ClassNK PSC Bulletin

Date:	26 February 2016
No:	NK-PSC-06
Attachment	No / Yes : page(s)

Fixed Gas Fire-Extinguishing Systems

(1) Example of dis-connected pilot line for CO2 discharge valve

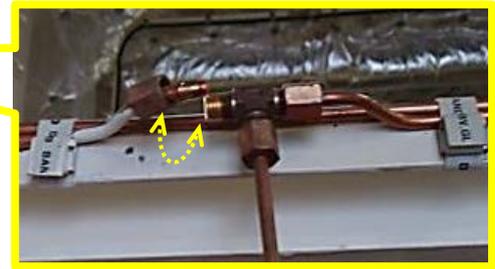
After servicing of Fixed CO2 Fire-Extinguishing System, some pilot lines remain disconnected. Accordingly, PSC points out that installation of the system is not ready for emergency use.

However, service suppliers may sometimes forget to reconnect some lines resulting in a deficiency being pointed out by PSC when the ship is later inspected by PSC. As a result, there have been reports that PSC has observed the installation of the fire-fighting system as not being ready for emergency use as a detainable deficiency, especially in Korea and Australia.

Even though the service supplier's report clearly states, "Ensure that pilot lines have been reconnected to all cylinders...", cases have been encountered where some pilot lines remained disconnected and was subsequently pointed out by PSC.

<Required action> After the service supplier's inspection/maintenance, special care should be taken by ship's crew to check and ensure that all pilot lines connections are properly in place.
